OBSERVATION REPORT

Project: **Strata Plan LMS 280 – Chateau Comox** File No. S18-558
1272 Comox Street Report No. 8
Vancouver, B.C.

ITEM: Building Envelope Field Review

Photos No. 8.1 and 8.2

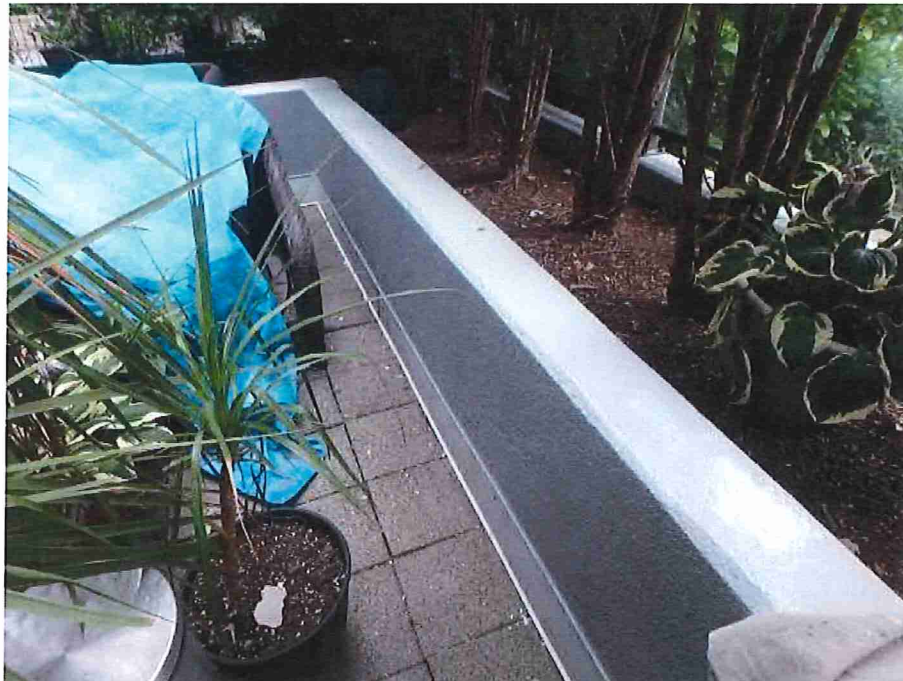
8.2	Painting and caulking work is substantially complete on the west half of the south elevation. The Dow Corning AllGuard silicone elastomeric coating has been applied to the exterior wall surfaces with good finish observed. At the time of review, the swing stage set up was being moved to cover the east half of the elevation so access was not immediately available. Detailed review will be conducted after the new swing stage set up is complete (Photo No. 8.1).

8.3	Work is continuing on the southwest corner balconies where new polyurethane traffic membrane is being installed. At the lower balconies, very good workmanship is observed. The membrane is applied to sufficient thickness and the broadcast sand is evenly distributed and back rolled into the top coat has required. Traffic membrane has been extended up the inside face of the parapet walls and onto the top surface of the parapet as requested (Photos No. 8.2 and 8.3).

Photos No. 8.5 and 8.6

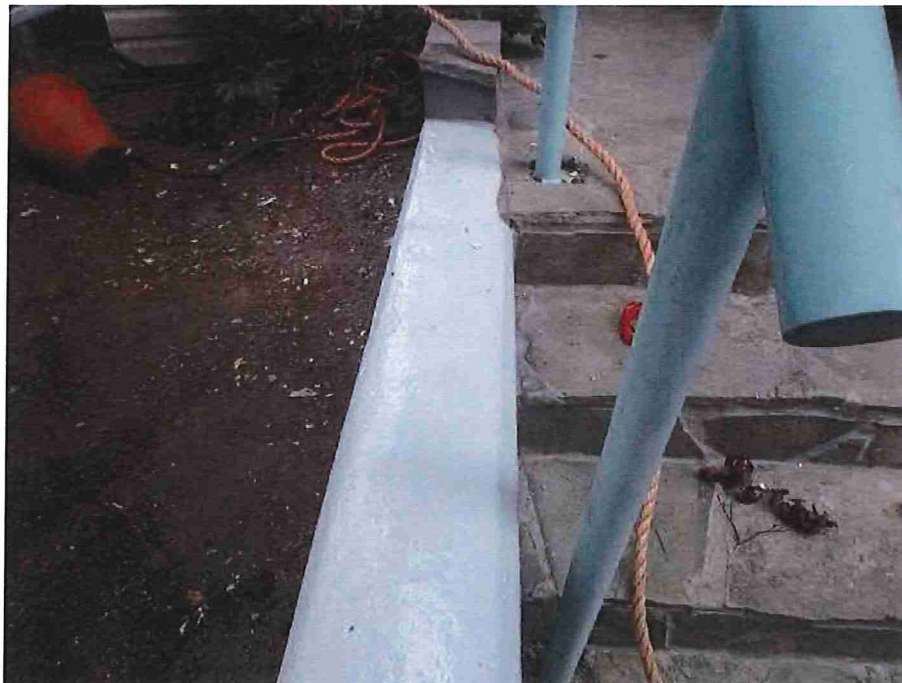
- 8.4 At one balcony only, the polyurethane traffic membrane application showed signs of delamination – blisters and pock marks in the finished surface. SEE conducted a small cut test which revealed a significant issue with concrete dusting on the existing balcony slab. Additional cut tests were done which showed the concrete dusting issue to be wide spread on this balcony. Unfortunately, the newly applied membrane on the balcony horizontal surface must be peeled off to expose the bare concrete slab. At the perimeter edges, and any location where tenaciously adhered membrane is discovered, the surface of the remaining membrane should be lightly touched with a grinder to provide a feathered edge into the bare concrete. After removal, the entire concrete surface must be heavily power washed, possibly with multiple passes until the entire weak layer of concrete on the top surface of the slab has been removed. We recommend testing during power washing with a scraper or stiff bristle brush – any areas which produce muddy water must receive further power washing until scraping or rubbing the bare concrete surface produces no residue.

- 8.7 At the southwest ground floor deck, planter walls are painted and horizontal surfaces have been prepared with new polyurethane traffic membrane. Work appears very good. In multiple locations on the planter and building walls, the contractor has removed failed acrylic stucco and applied new with an excellent match to the existing texture (Photos No. 8.6 to 8.8).
-

-
- 8.5 After washing is complete, the deck must be allowed several days to dry. We recommend an adhesion test be performed on a small area of the deck, 6" wide by 12" long to confirm the surface prep procedures successfully removed all weak dusting concrete. In the test patch, embed scrim cloth within a standard application of membrane base coat and allow to dry. Please notify SEE in advance so that we can witness the pull off and confirm adhesion of the base coat is satisfactory.
-

- 8.6 After successfully completing the adhesion test, new base coat membrane should be applied to the bare concrete areas, feathered into the existing membrane application. New top coat shall be applied to the entire horizontal surface of the deck. All locations of existing membrane must be prepared with a heavy solvent wipe of xylene to ensure a good bond with the new top coat.
-

Photos No. 8.13 and 8.14

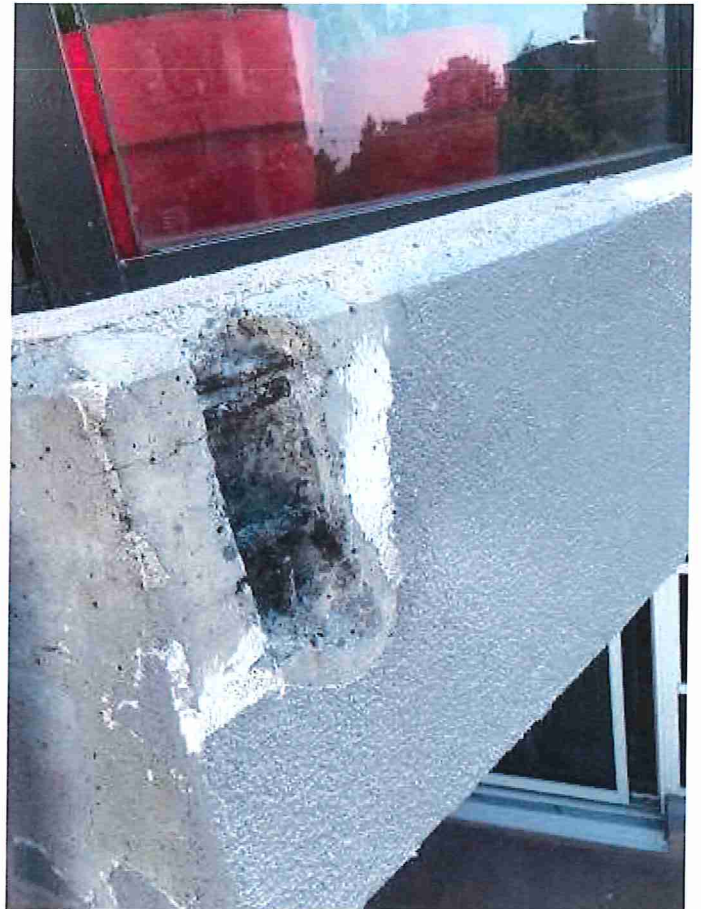
- 8.8 On the south elevation drop, numerous concrete repairs were required due to reinforcing steel with insufficient concrete cover. The steel began to rust resulting in spalling concrete. The contractor has been making repairs at the direction of SEE with their progress photos attached to this item (Photos No. 8.9 to 8.18).
- 8.9 On the west elevation at the side yard walkway the walls have been painted with good finish observed. Many rout and caulk repairs have been completed in the exterior concrete walls (Photo No. 8.19).
